Errata

Drift Reduction Factors for Belted High-Rise Structures

Paper presented by J. W. McNabb and B. B. Muvdi
(3rd Quarter, 1975)

Fig. 6. Dimensionless deflection vs. γ for $\alpha = 0.75$

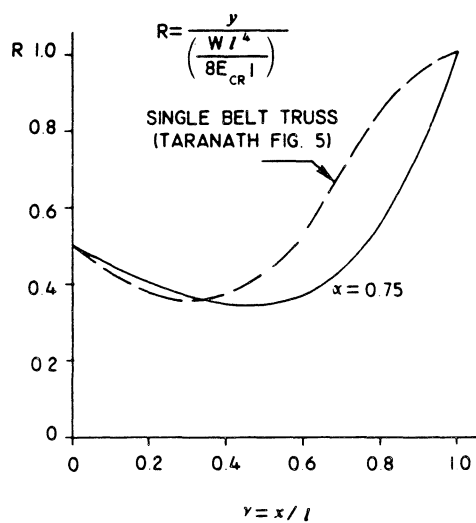
Figure 6, which was inadvertently omitted from this paper, is shown below:
